MONITOR BOUNDARY PHASE 53

COED DARCY

Contract Name:	Coed Darcy Monitor	RFI No:
Contract Number:	GNP/NJR/13773-2	Date Raised: 6 May 2015
Subject:	Review of Atkins' Validation Report for Monitor Phase 53	
To:	Michelle Lee	Atkins
Cc:	Mike Poland	Atkins
From:	Rhys Mander	AECOM

The following queries are raised in relation to Atkins' Validation Report for Monitor Phase 53 (report ref. 5041216/REM/RPT/0001332) and Atkins' subsequent Technical Note ref. 5041216-OSW-TN-0001350:

DRAWING NO	5041216-REM-DWG-1777	REV	-
------------	----------------------	-----	---

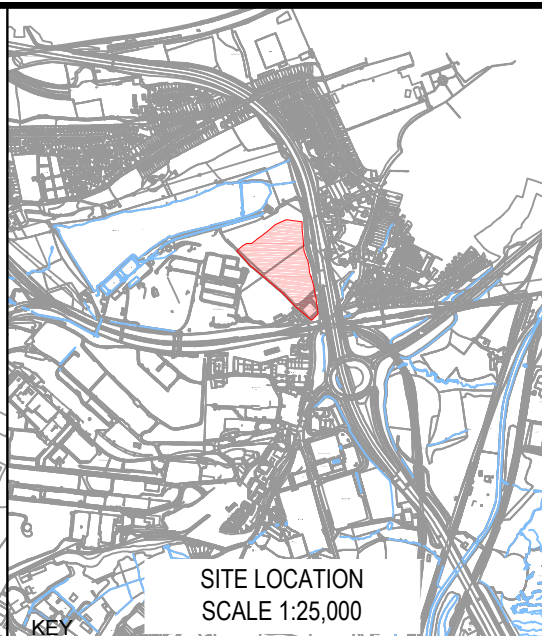
- Section 5.2 states that trial pits surrounding NSE52 were excavated to bedrock with no visual or olfactory evidence of contamination recorded in soil or on bedrock. Should this read NSE53? Do these additional trial pits have reference numbers and logs and are they shown on drawing 5041216-REM-DWG-1777?

- Similarly, section 6.2.2 states that an additional trial pit was excavated within the vicinity of NSE31. Does this trial pit have a reference number and log and is it shown on drawing 5041216-REM-DWG-1777?
